2. Residential Amenity Response

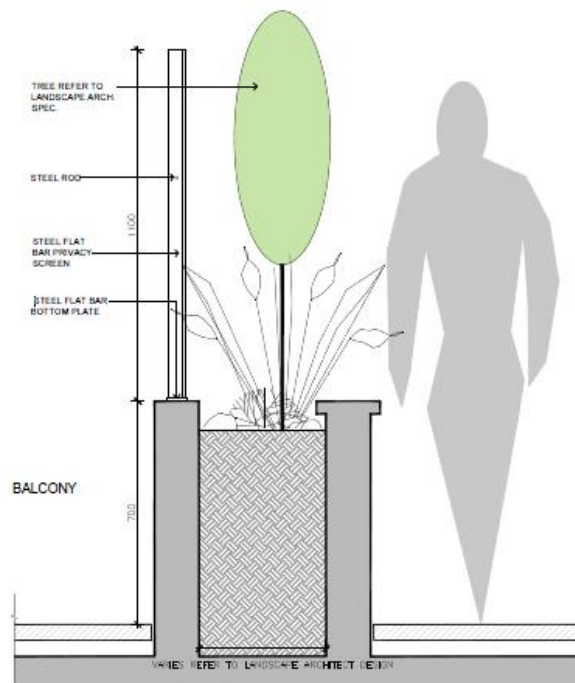
• Provide further consideration of the amenity of apartment 2.02.13 and the six identical apartments above, given they would not be cross-ventilated, would receive limited solar access, only satisfy minimum size and balcony size recommendations, and have limited	Refer to updated DA-10-5200, DA-10-5300, DA-10-5400, DA-10-5500, DA-10-5500 & DA-10-5600. Given this is the single-aspect apartment facing to the west, these 7 apartments are less desirable than most of the others in the development. It is notably the application still achieve 70% solar & 60% cross ventilation compliance. Attached floor plan illustrates furnished layout of bedroom apartment providing good, essential amenity and ample space to moving around the furniture. Additionally a window is added to the living room, improving natural ventilation.

outlook and privacy
(due to orientation
directly towards No.
4 Murray Rose
Avenue).

2. APT 1.01.13 & 1.01.14

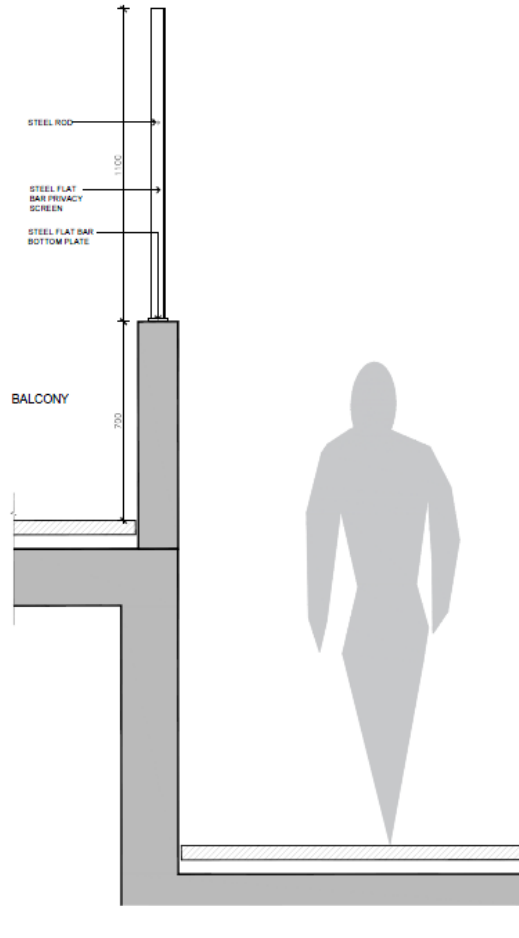
- Demonstrate how privacy and amenity would be achieved to the balcony/living areas of apartments 1.00.01, 1.00.02, 1.00.03, 1.00.10, 1.01.13, 1.01.14, 1.08.01, 2.00.01, 2.01.01, 2.01.02 and 2.01.03. Consideration must also be given to the implication of any proposed privacy screens/landscaping on solar access to these apartments.

Where the balconies are right along the boundary, the 1.8m tall fence detail is proposed with 700mm high solid balustrade, preventing any concerns of overlooking.

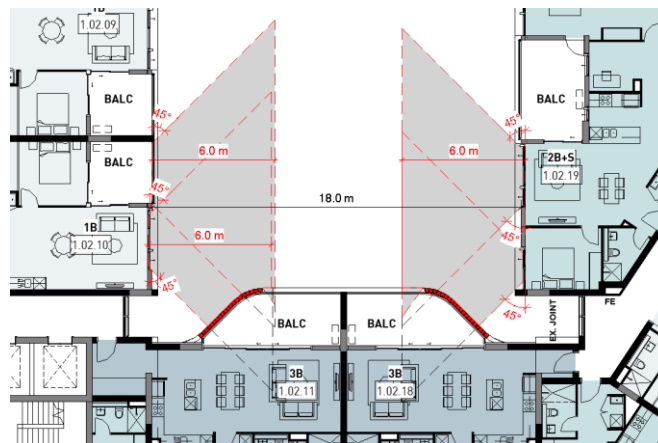
- Provide further information and consideration regarding the proposed privacy mitigation measures and lines of sight between the balconies serving apartments 1.02.11 and 1.02.18 (and the identical apartments above), and the habitable rooms and balconies of units 1.02.10 and 1.02.19 (and the identical apartments above).

Vertical louvre at balcony is provided additional privacy to 1.02.11 & 1.02.18 (and the identical apartments above) from the neighbouring.

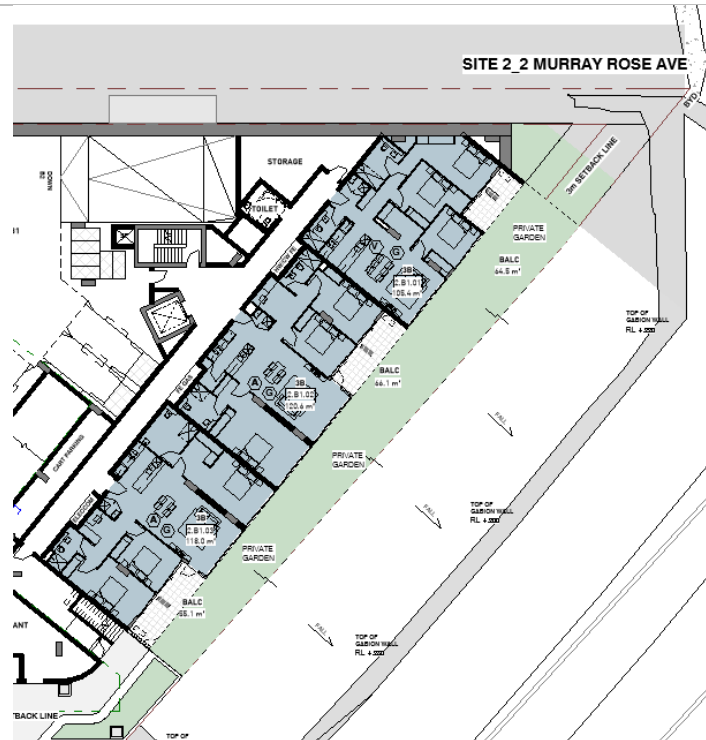
Confirm why apartments 1.07.13 and 1.07.14 are identified as cross-ventilated in drawing DA-94-0000	Apartments 1.07.13 and 1.07.14 are not cross-ventilated. Refer to updated DA-94-0000 Cross Ventilation Compliance Diagram, showing overall 60% compliance.
Provide plans demonstrating compliance with ADG minimum storage volume recommendations (including provision of a minimum of 50% within the apartment)	Refer to new series 70 - Storage Schedules and Plans.
Provide revised plans demonstrating deep soil area calculations and clearly identifying areas that satisfy the ADG 6m minimum dimension recommendation. It also appears the deep soil area illustrated on drawing L0.01 includes the area occupied by balconies on the eastern side of both proposed buildings,	Refer to Appendix J for deep soil dimensions. S1

as shown on the
architectural plans.

Updated Architectural Plan DA-10-1900 & DA-10-4900

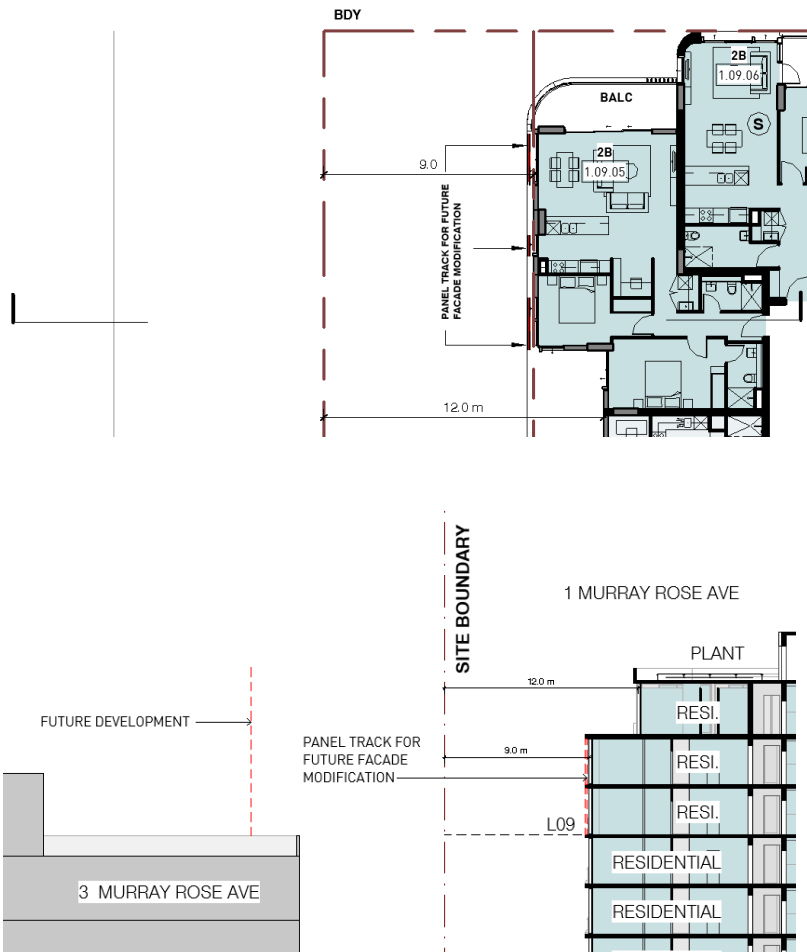
- Provide further details of proposed privacy mitigation measures on western elevation of Building 1 (level 9 and above)
